LARSON RIVER ROAD AUTO STORAGE

Project Title
LARSON RIVER ROAD STORAGE

Issue Set & Date:
PERMIT SET
09/23/2022

City Comments 09/01/2022 TCS

Sheet Title:
LANDSCAPE PLAN

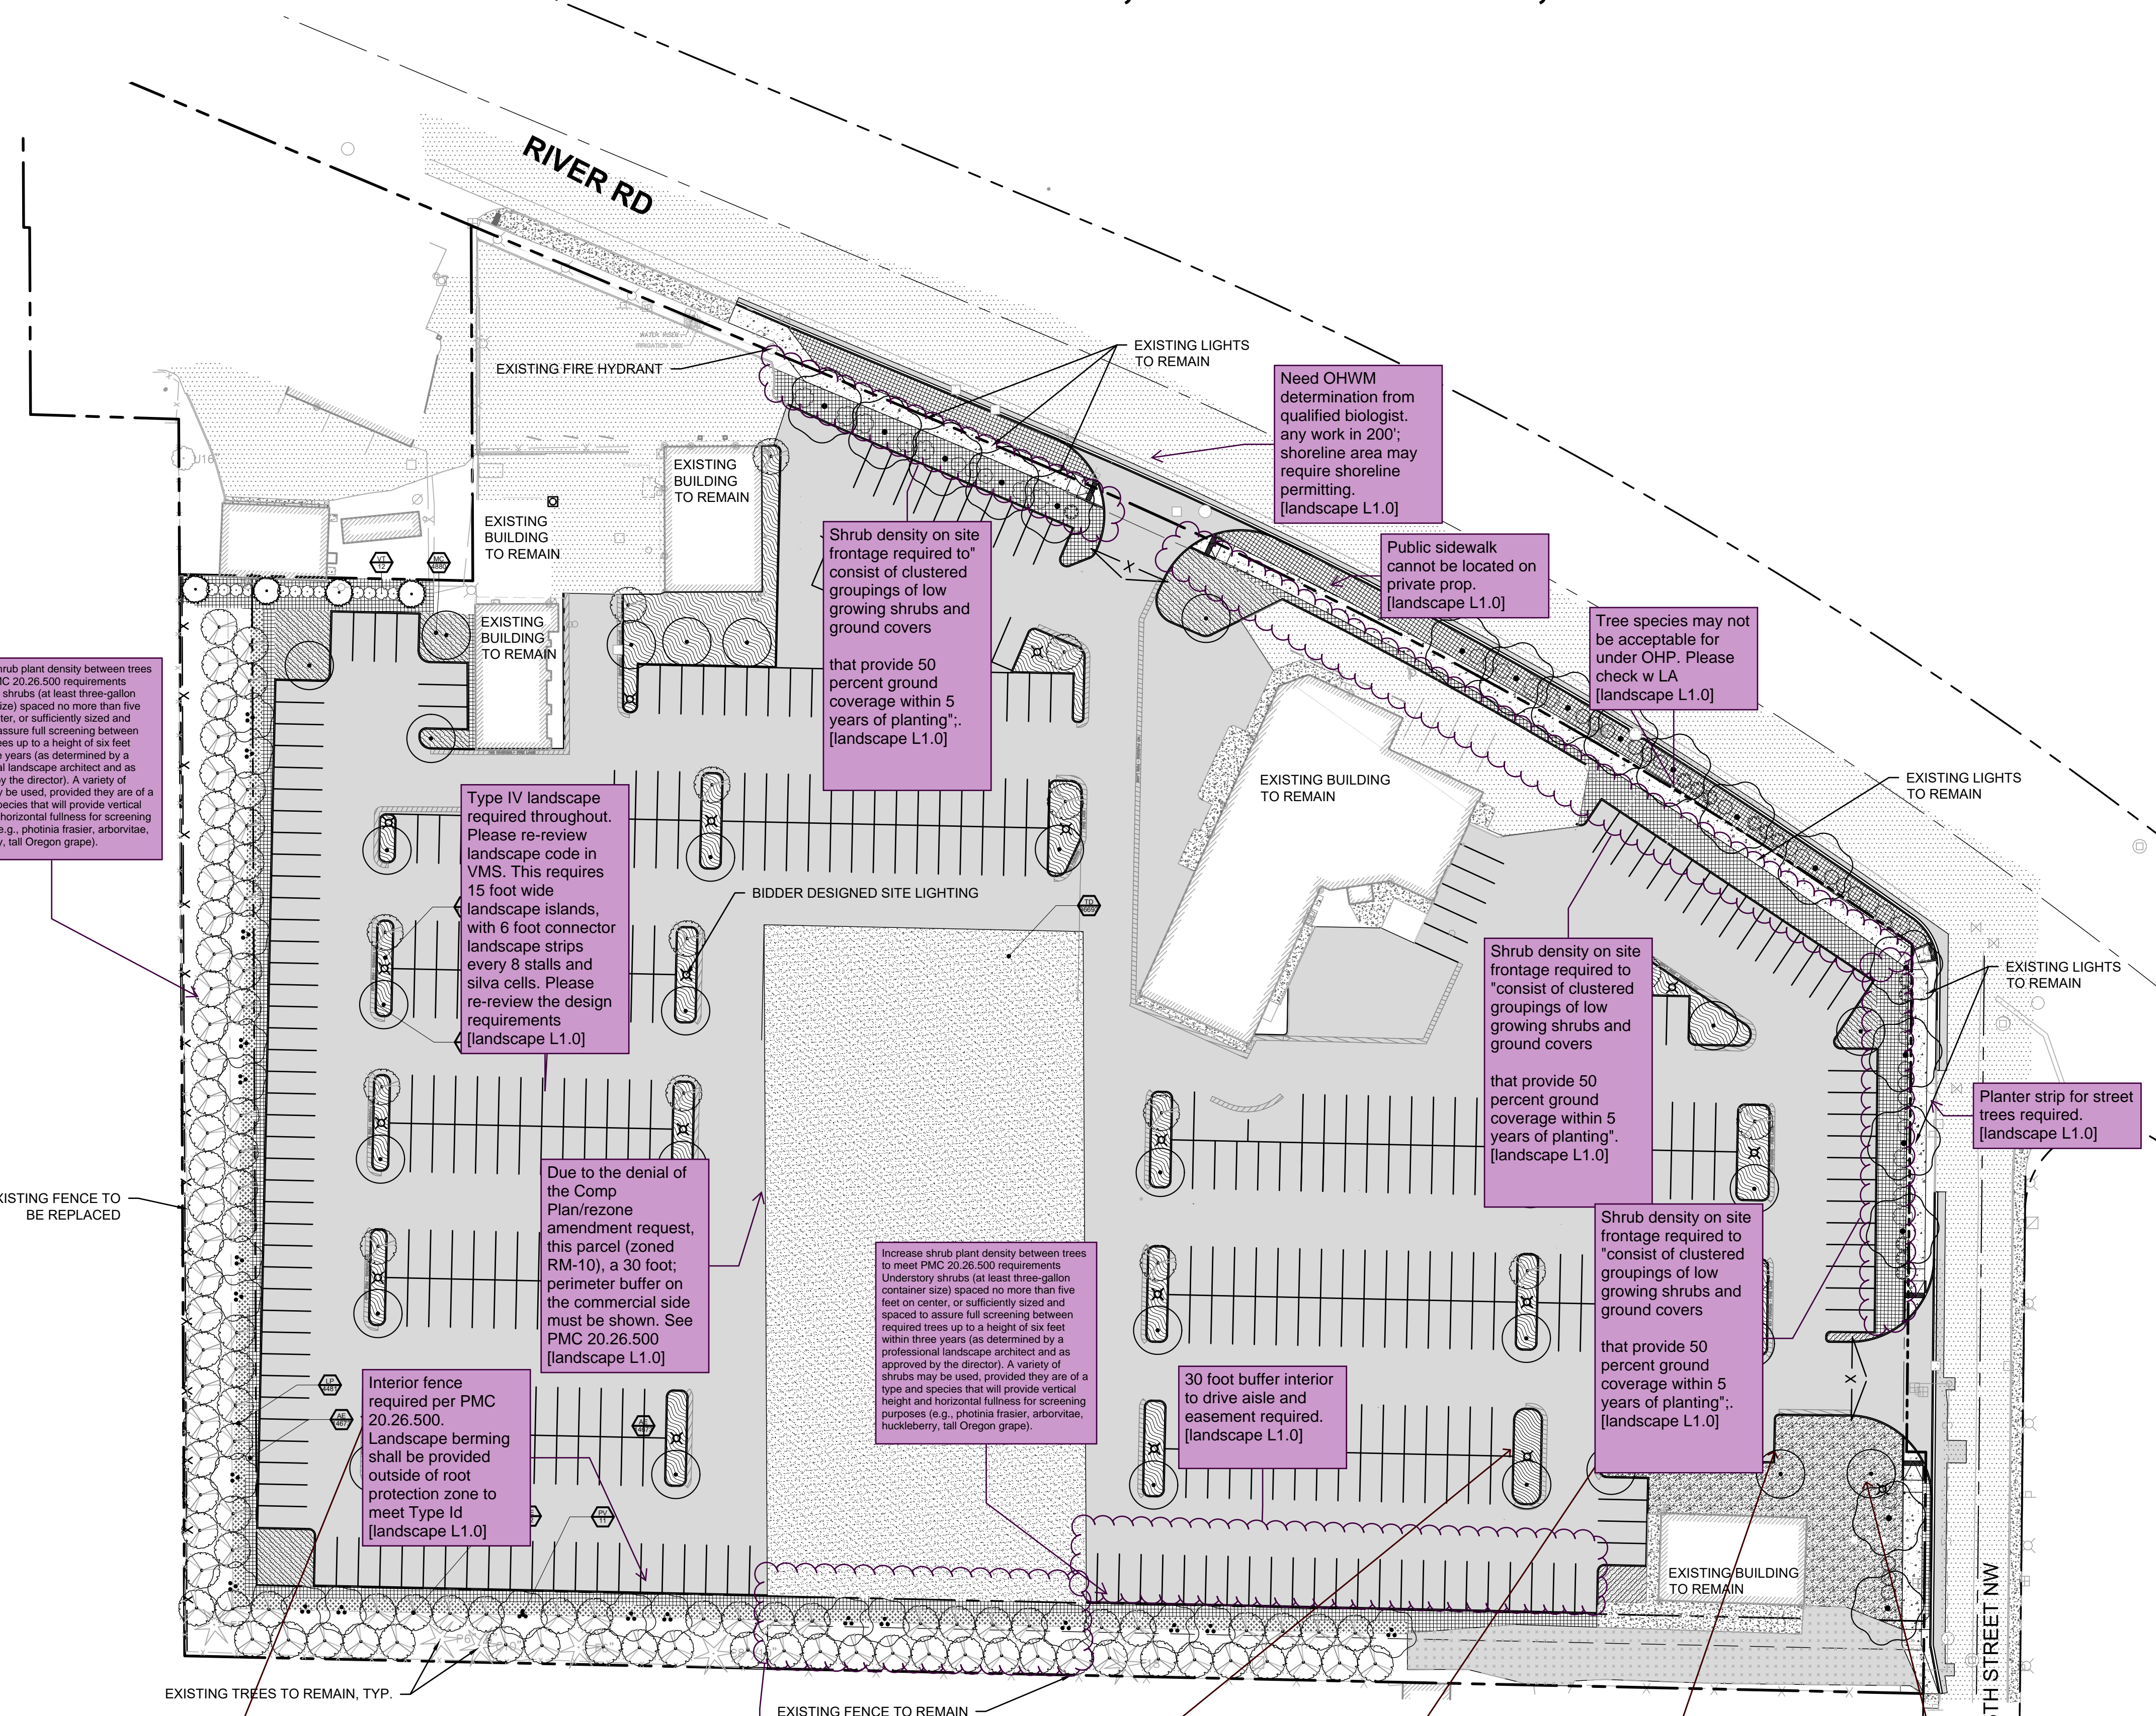
Increase shrub plant density between trees to meet PMC 20.26.500 requirements. Understory shrubs (at least three-gallon container size) spaced no more than five feet on center, or sufficiently sized and spaced to assure full screening between required trees up to a height of six feet within three years (as determined by a professional landscape architect and as approved by the director). A variety of shrubs may be used, provided they are of a type and species that will provide vertical height and horizontal fullness for screening purposes (e.g., photinia fraseri, arbovitae, huckleberry, tall Oregon grape).

Due to the denial of the Comp Plan/rezone amendment request, this parcel (zoned RM-10), a 30 foot perimeter buffer on the commercial side must be shown. See PMC 20.26.500 [landscape L1.0]

Shrub density on site frontage required to "consist of clustered groupings of low growing shrubs and ground covers that provide 50 percent ground coverage within 5 years of planting". [landscape L1.0]

Increase shrub plant density between trees to meet PMC 20.26.500 requirements. Understory shrubs (at least three-gallon container size) spaced no more than five feet on center, or sufficiently sized and spaced to assure full screening between required trees up to a height of six feet within three years (as determined by a professional landscape architect and as approved by the director). A variety of shrubs may be used, provided they are of a type and species that will provide vertical height and horizontal fullness for screening purposes (e.g., photinia fraseri, arbovitae, huckleberry, tall Oregon grape).

Shrub density on site frontage required to "consist of clustered groupings of low growing shrubs and ground covers that provide 50 percent ground coverage within 5 years of planting". [landscape L1.0]

Shrub density on site frontage required to "consist of clustered groupings of low growing shrubs and ground covers that provide 50 percent ground coverage within 5 years of planting". [landscape L1.0]

Planter strip for street trees required. [landscape L1.0]

Sheet L1.0 - No trees within 10-feet of a water main.

Sheet L1.0 - No trees within 10-feet of a water main.

Sheet L1.0 - No trees within 10-feet of a water main.

Sheet L1.0 - No trees within 10-feet of a water main.

Sheet L1.0 - No trees within 10-feet of a water main.

Perimeter not required adjacent to RM-10 parcel due to the denial of the Comp Plan/rezone amendment request. Leave this area.
